Ref: **CPP Project 18496**

Portside Build to Rent wind assessment following proposed changes

Figure 1: Proposed changes to the development (5-point Projects, 2025)

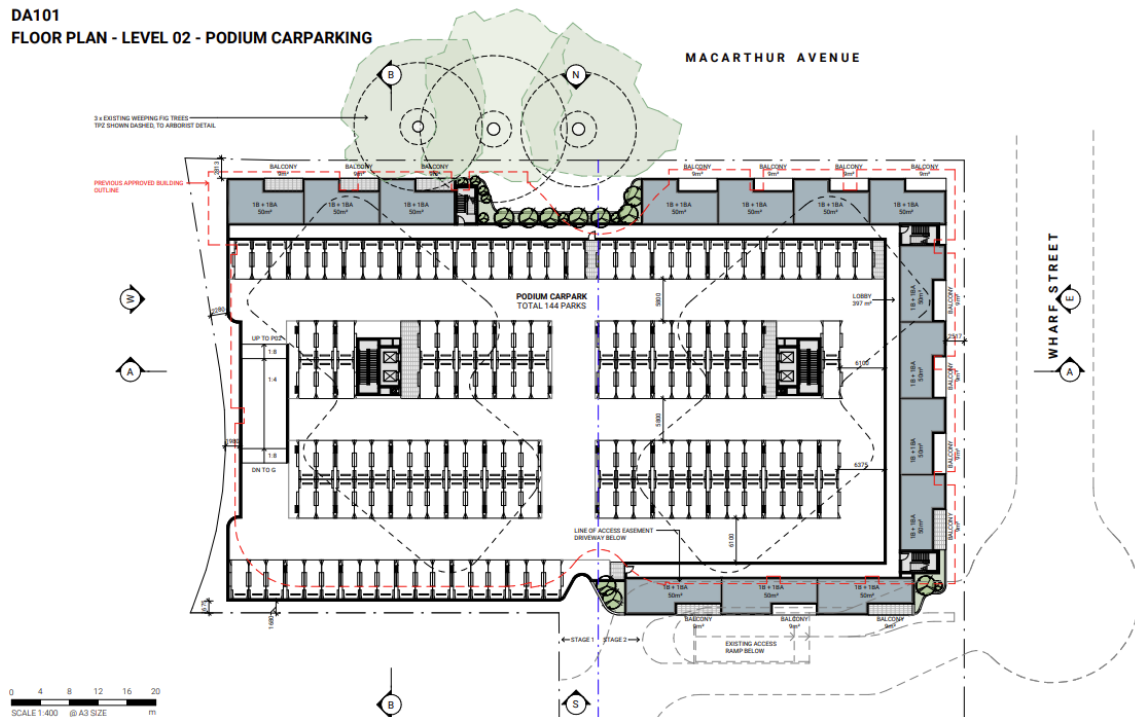
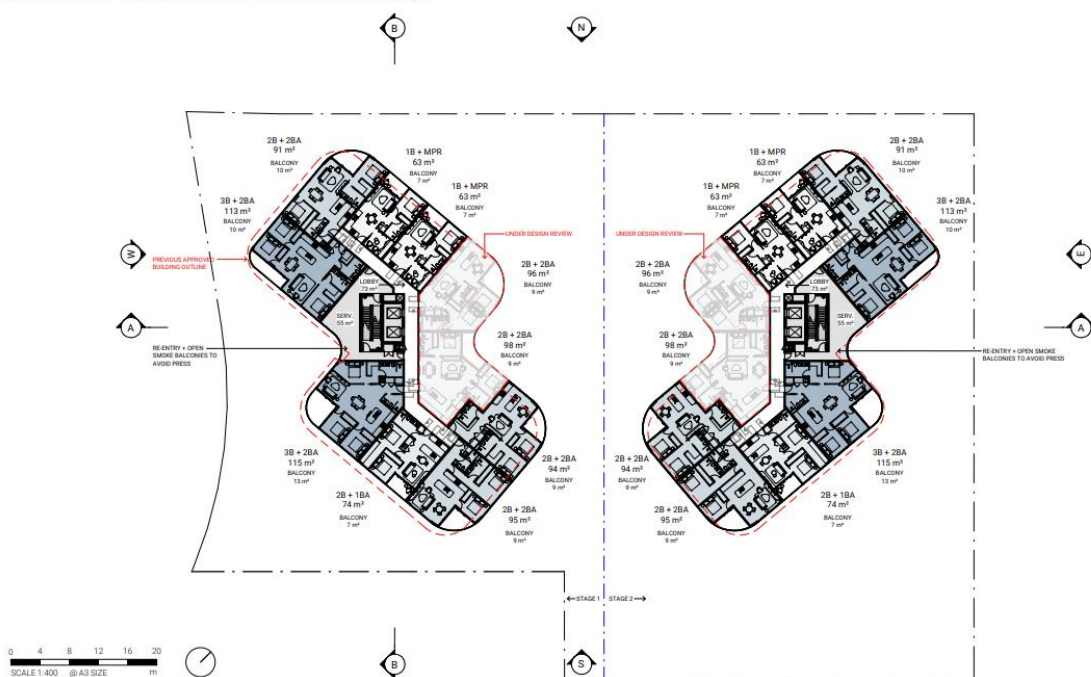
The proposed changes result in podium balconies which are inset from the podium façade. This is a positive design feature and will reduce the exposure of these balconies to windy conditions.

The proposed changes appear to remove the residence lounge connecting the two towers on the podium rooftop including the awnings extending from the lounge to the north along both buildings. This will increase the susceptibility of parts of the podium between the two towers to flow channelling between the two towers, leading to increased wind speeds for this location. An updated landscaping plan received by CPP (04 August 2025) indicates that much of the

podium terrace between the buildings is dedicated to pedestrian transit and landscaping. Additional dense landscaping is also planned for the southern portion of the terrace which will assist in limiting the effects of flow channelling between the buildings. The resulting conditions are expected to be consistent with the intended use of these areas for walking and other non-stationary activities. Wind conditions in the remaining areas such as the meditation lawn and dog lawn can be managed using localised mitigation measures such as vertical screens, dense landscaping or raised planters, which 5Point indicates are planned for the podium.

The proposed changes to the planform of the towers are minor and the tower balcony positions and sizing remain similar to the original design. Therefore, the original qualitative assessment is applicable for these locations.

Figure 2: Proposed ground-level floor plan (5-point Projects, 2025)

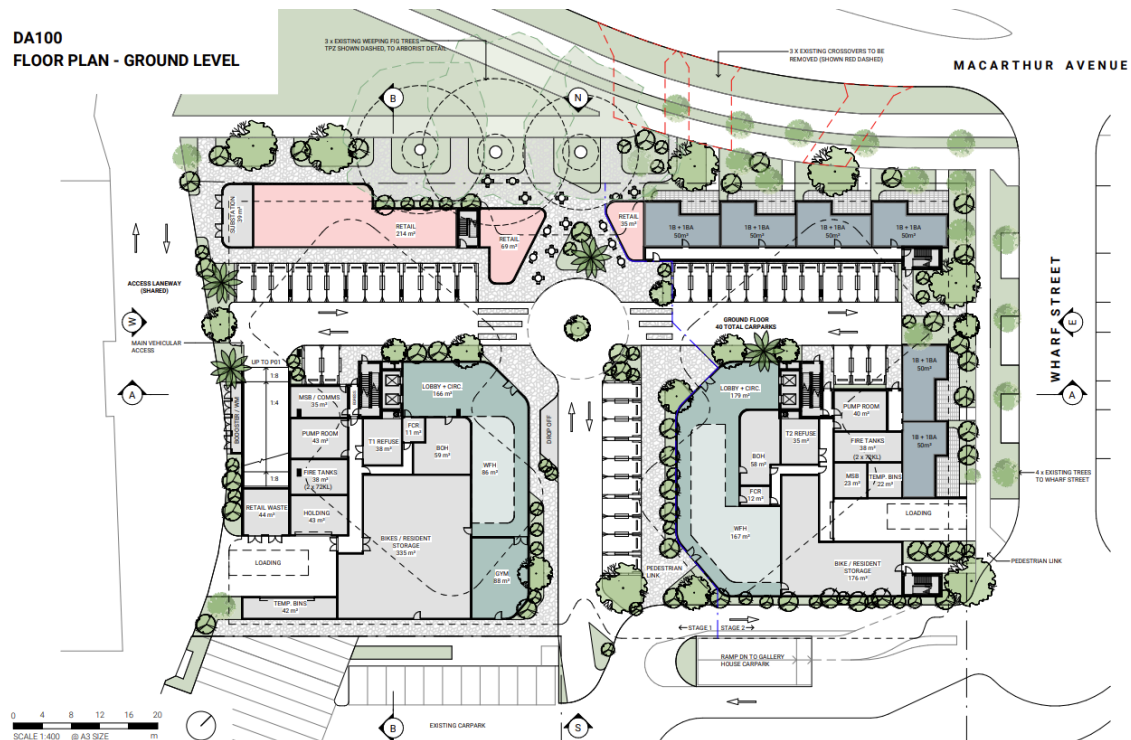
The proposed design changes, Figure 2, remove the external doors which were previously present in the crosswalk link area on the ground level (underneath the podium) and also introduce openings on the east and west side of the ground level. These changes are expected to cause increased wind speeds for the northern portion of the arcade during prevailing winds from the north to north-east due to pressure-driven flow. As this area may be used for outdoor dining (depending on the tenants), mitigation measures would be recommended. For winds from the north to north-east, positive pressures on the north side of the development would effectively be connected by these openings to negative pressures on the south, and particularly the east and west side of the development. While not as prevalent as south-westerly winds, winds from the north-north-east occur regularly in Brisbane. Higher wind speeds are relatively frequent from this direction, along with the west.

This wind-induced pressure distribution around the building, combined with the chamfered north corridor is likely to generate a strong breeze through the north opening which is then channelled out through the east and west openings. Wind conditions in this area are expected be consistent with a Pedestrian Walking comfort rating based on the Lawson wind comfort criteria. For longer-term stationary activities, a milder rating (Pedestrian Sitting or Outdoor Dining) would generally be preferable. However, for warmer climates, it can sometimes be desirable to have higher wind speeds to provide relief from the heat. For Brisbane specifically, north to north-easterly winds which drive the increased wind speeds are more prevalent during the summer months than winter. While this may assist with the comfort level experienced by pedestrians to an extent, mitigation measures would still be recommended for longer term stationary activities. These can be achieved by positioning outdoor dining areas to the north of the retail spaces, where milder wind conditions would be available, away from the northern opening. The rest of the ground level area, which encompasses the majority of the space, appears to be dedicated to transit. The wind conditions in this area are generally expected to be suitable for the intended purpose of this space.
